Interim Reclamation and Stormwater Inspection

Inspection Document #: 708200320

Inspection Photos
Location Name: Davis Battery
Location ID: 426218

Photo 2. See comments in Photo 1.

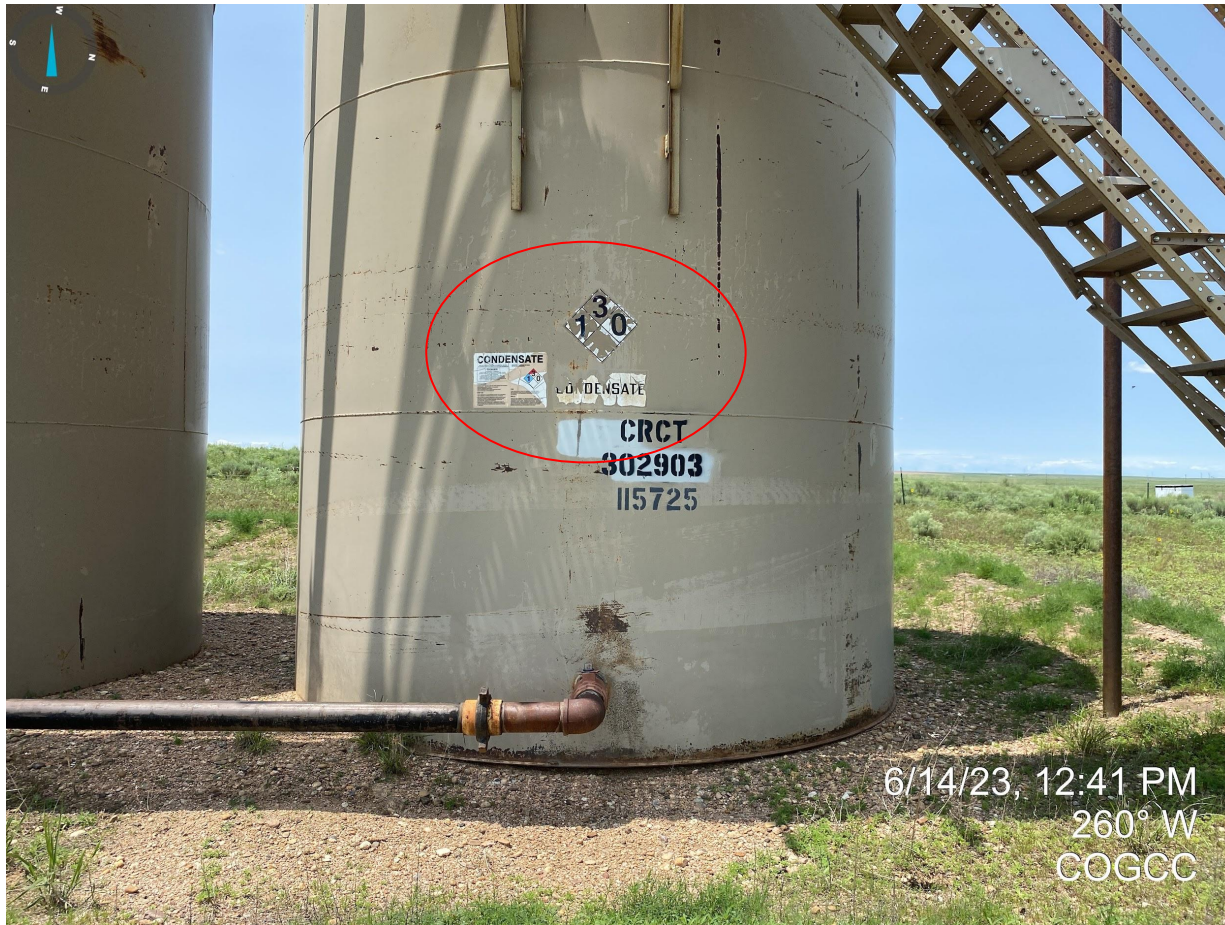
Photo 1. Location signage is not legible (e.g. peeling, faded, cracked, incorrect information). Comply with Rule 605.g.
